## REMARKS

This is intended as a full and complete response to the Office Action dated June 15, 2004, having a shortened statutory period for response extended two months set to expire on November 15, 2004. Please reconsider the claims pending in the application for reasons discussed below.

**IN THE DRAWINGS:**

Fig. 3B

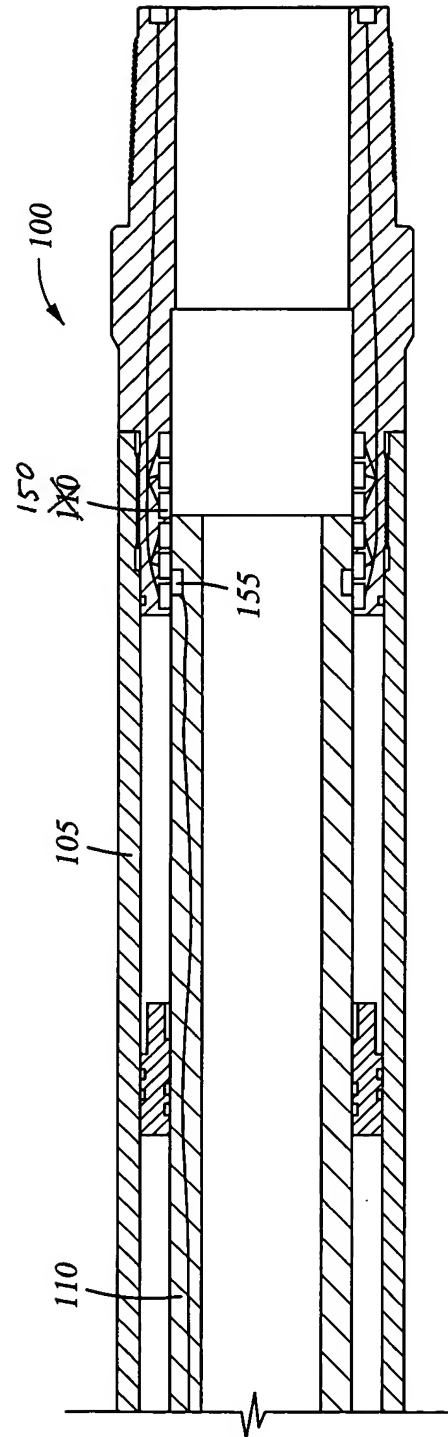
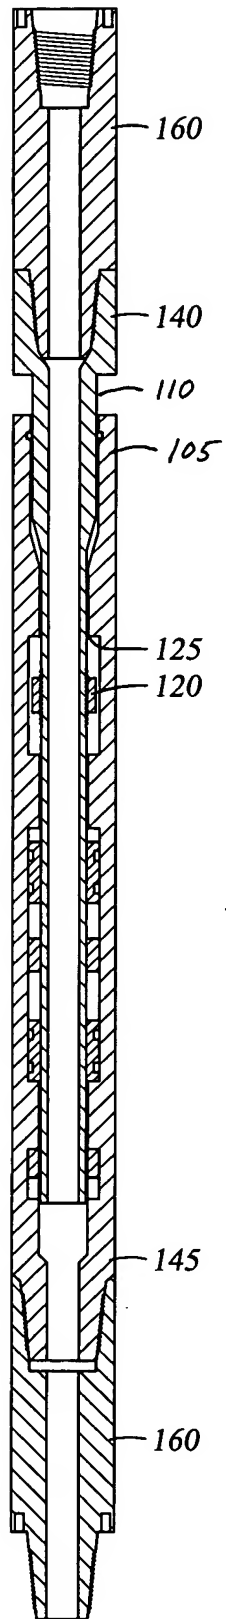
The drawings stand objected to under 37 C.F.R. § 1.83(a) for failure to show the claimed element "sensor." Applicants propose amendments to the drawings to correct minor editorial problems and to overcome the objection under 37 C.F.R. § 1.83(a). Applicants have submitted the proposed corrections marked in red on the attached copies of the original drawings filed in the application. The proposed corrections conform the drawings to the written description of the invention. The proposed amendment to Figure 3B rennumbers previously mislabeled element 150. The proposed amendments to Figure 4 entail insertion of omitted labels 110 and 105. The proposed amendments to Figures 5A and 5B entail insertion of omitted label 100 and a labeling correction for previously mislabeled element 175. The proposed amendment to Figures 6a and 6B entails insertion of omitted label 100. The proposed amendment to Figure 7A entails insertion of omitted label 217. The proposed amendment to Figure 9 entails insertion of omitted label 100. The proposed amendments to Figures 11A and 11B entail deletion of extraneous label 80 and insertion of previously omitted labels for sensor 98 and vibrator 99. The sensor is described in the specification in paragraphs [0037], [0045], [0046], [0048], and [0050]. The vibrator is described in the specification in paragraph [0051]. Accordingly, Applicants submit that the proposed amendments do not introduce new

The attached sheets of drawings include changes to Figure 3B, Figure 4, Figure 5A, Figure 5B, Figure 6A, Figure 6B, Figure 7A, Figure 9, Figure 11A, and Figure 11B, and replace the original sheets including Figure 3B, Figure 4, Figure 5A, Figure 5B, Figure 6A, Figure 6B, Figure 7A, Figure 9, Figure 11A, and Figure 11B.

Attached are 7 sheets of formal drawings showing the abovementioned changes and a marked-up copy of the original sheets. Please amend and admit Figures 3B, 4, 5A, 5B, 6A, 6B, 7A, 9, 11A, and 11B as shown in the attached sheets.
